INVITATION FOR BIDS
CCK-2563.30-7-25
CTC + AAC BP07 Core & Shell Group 2
Project# 2563.30
ADDENDUM #2
09/12/2024

Addendum #02

Client	University of Kentucky Healthcare	Date	09/11/2024
Project	UK CTC BP-07 Core and Shell Group 2	UK Project #	2563.0
		Champlin Project #	514-5350

SHEET NO.
A489

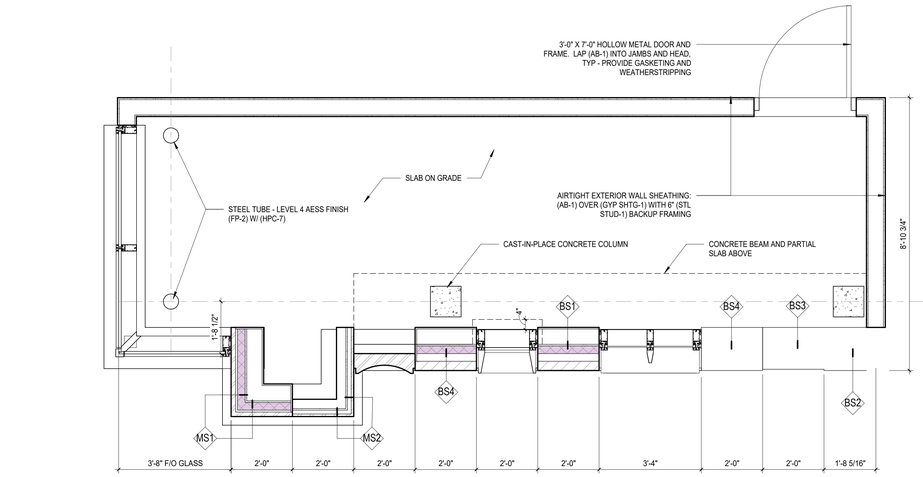
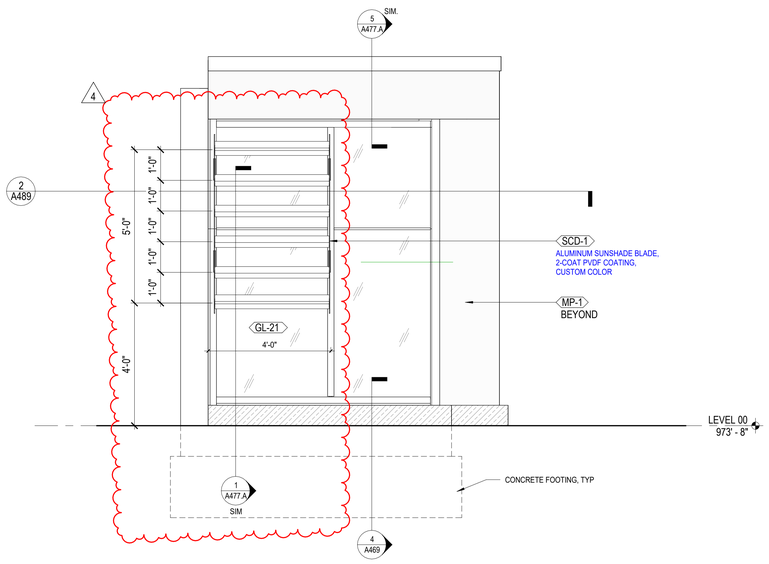
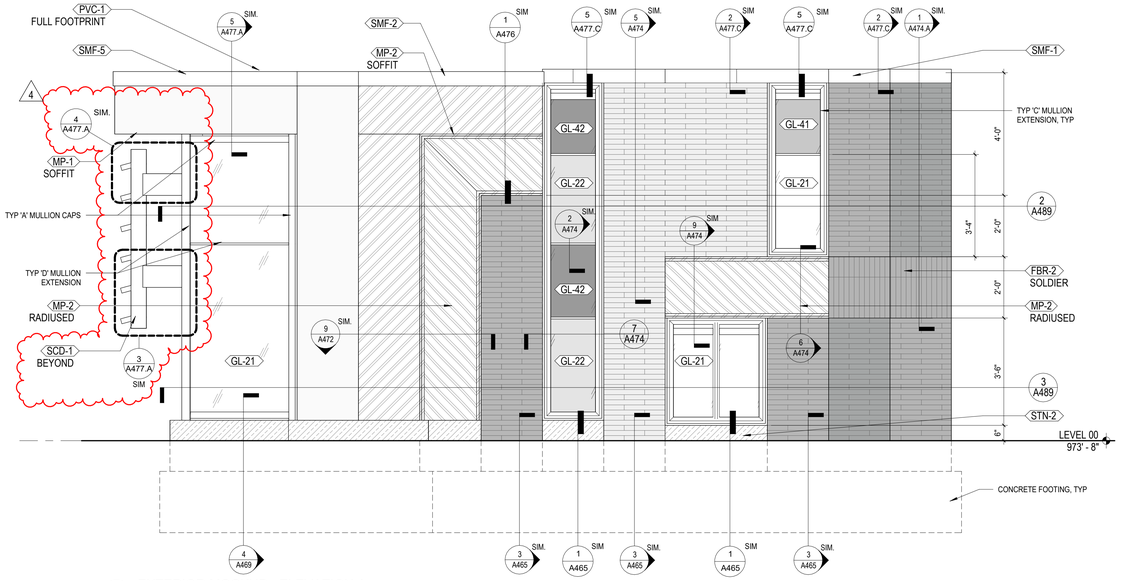
1. *Add sub shade to mock-up.*

3 W88 CW-2
1/8" = 1'-0"
1/A201

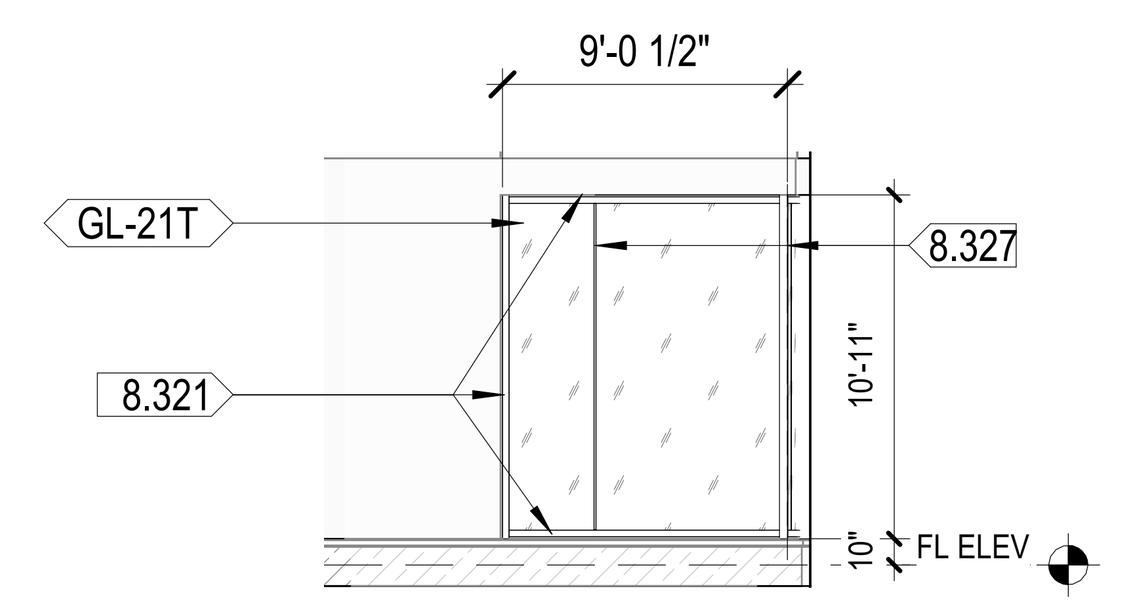
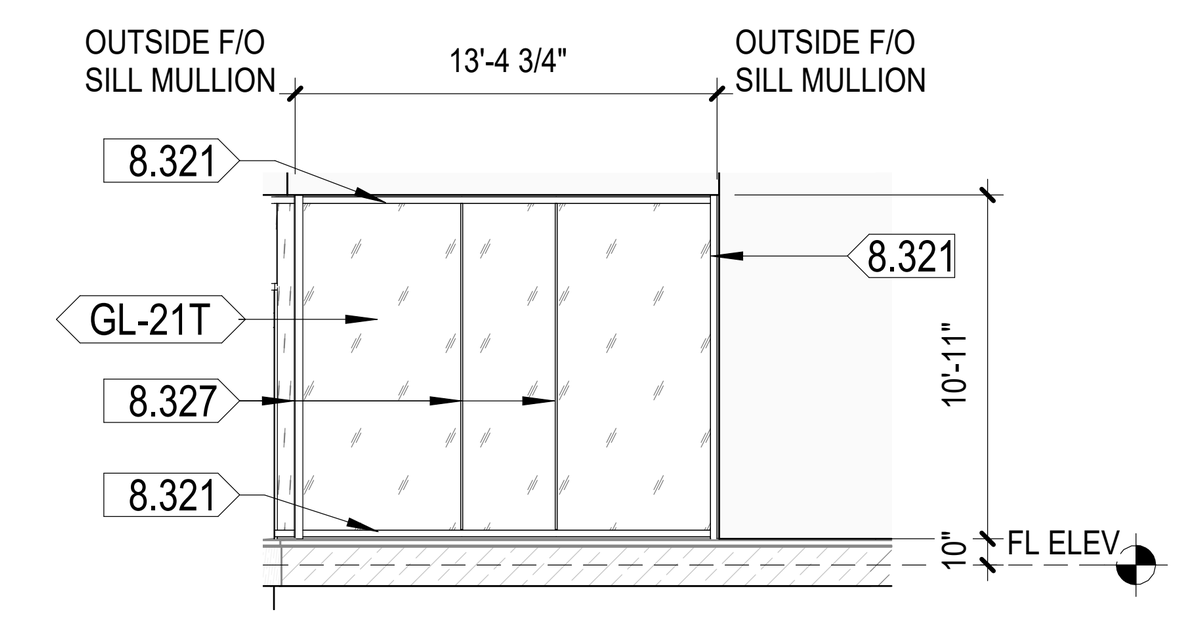
1. *Elevation 3: Remove spandrel glass at top of curtain wall.*
2. *Elevation 6: Add sill detail reference.*
3. *Added tag for louver type "L4." Added exterior elevations for main vestibule to cue in curtainwall types W87 and W88 and clarify metal panel finishes.*

7 W81 CW-1
1/8" = 1'-0"

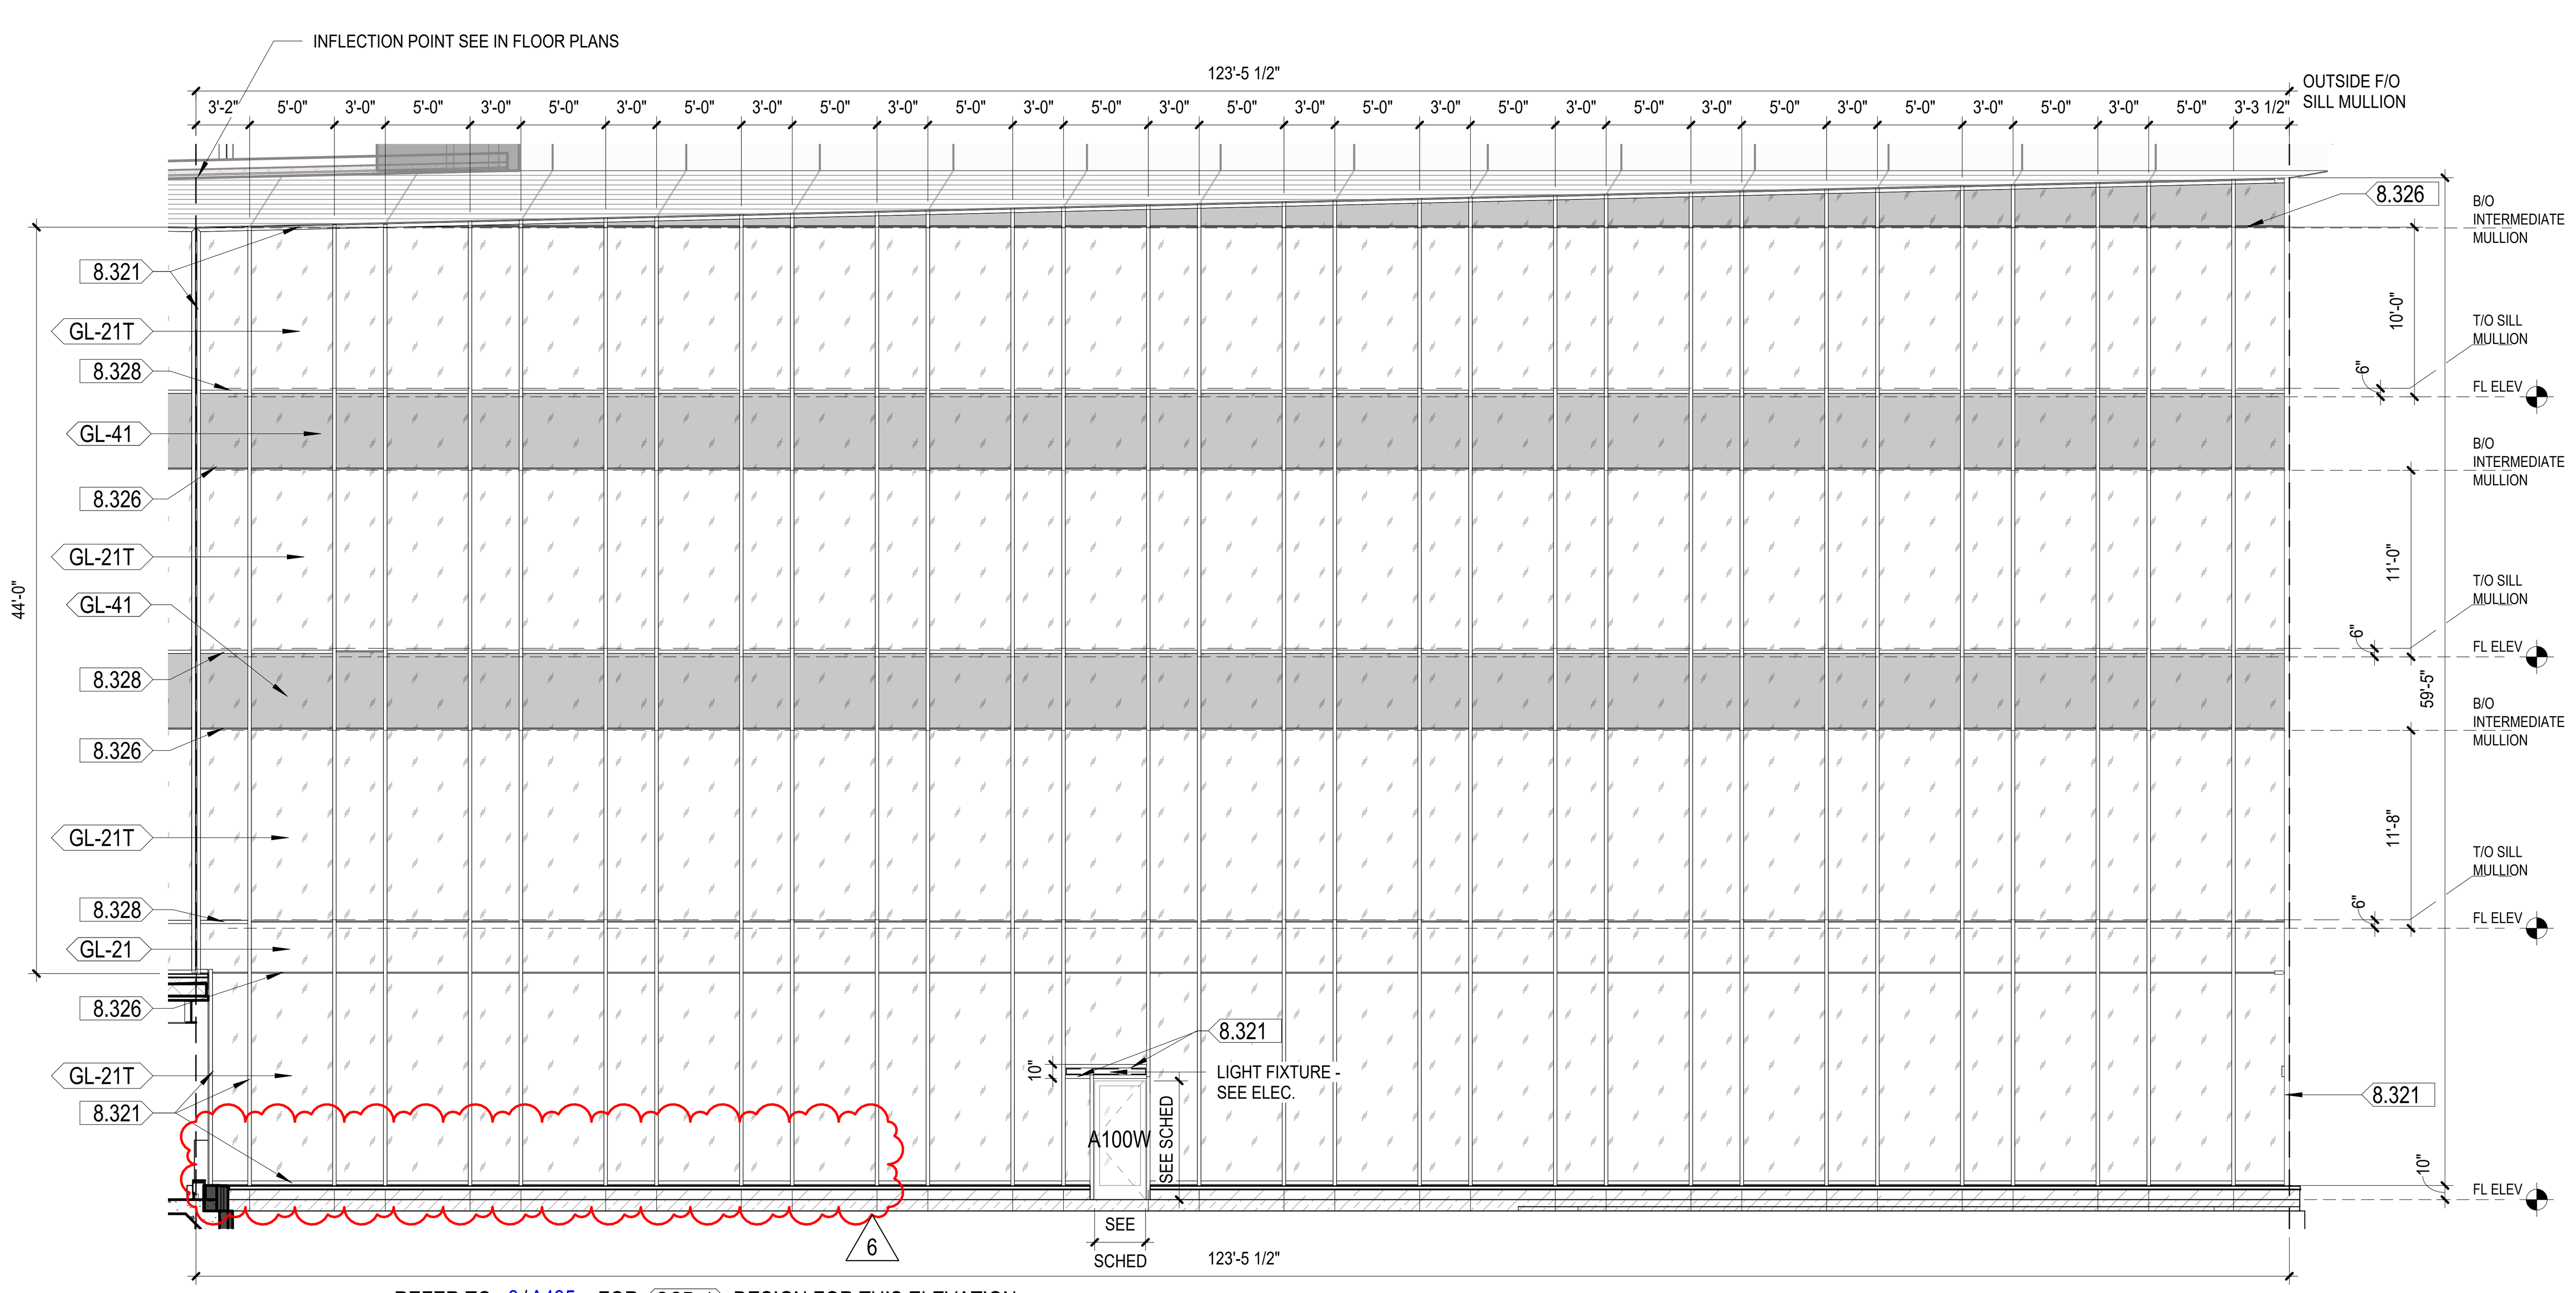
1. *Detail stone knee wall on Curtain Wall Elevation W81 and extend curtain wall down.*

A532-ENLARGED SHAFT SH10 PLANS AND SECTIONS

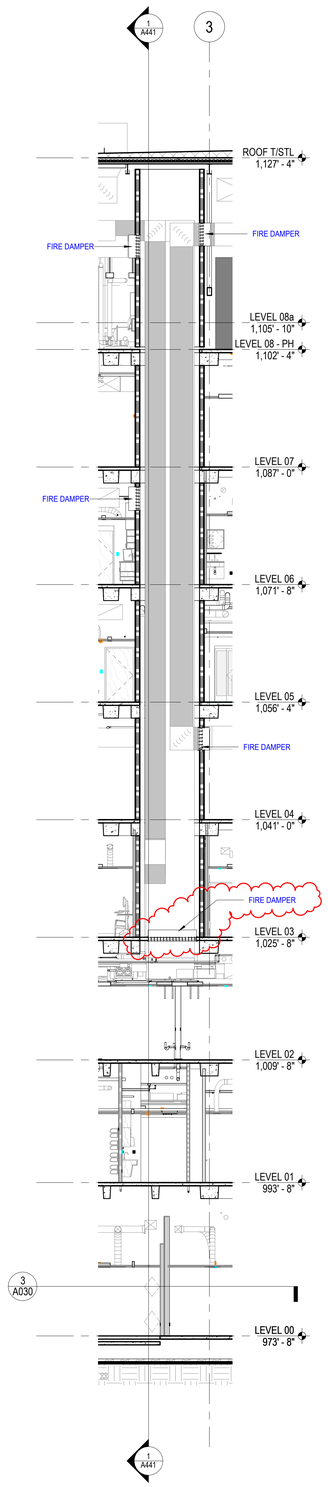
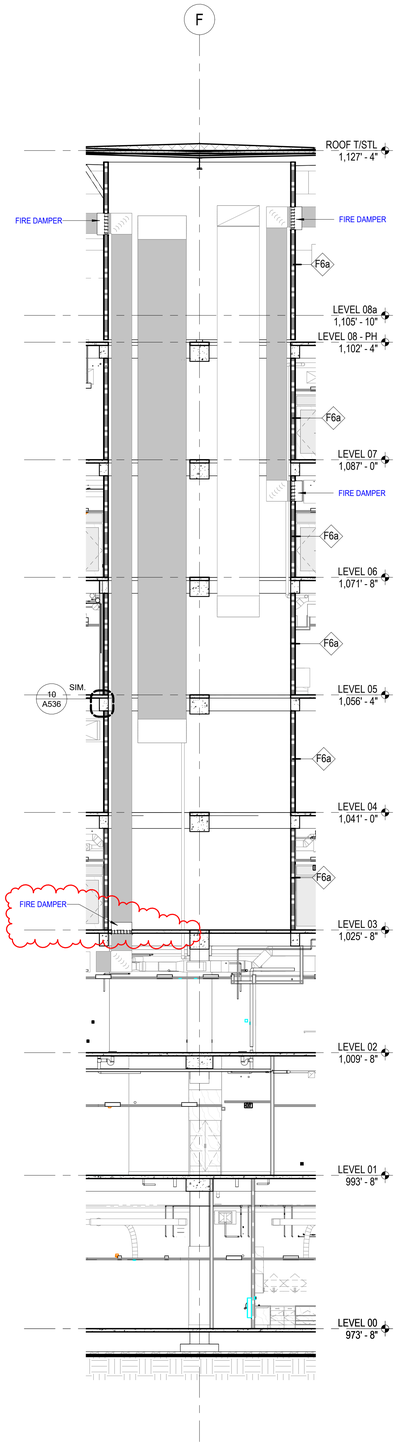
1. *Revise bottom of shaft to indicate shaft closed off at floor level by slab and fire damper to be located in slab. Dog house below slab has been deleted.*
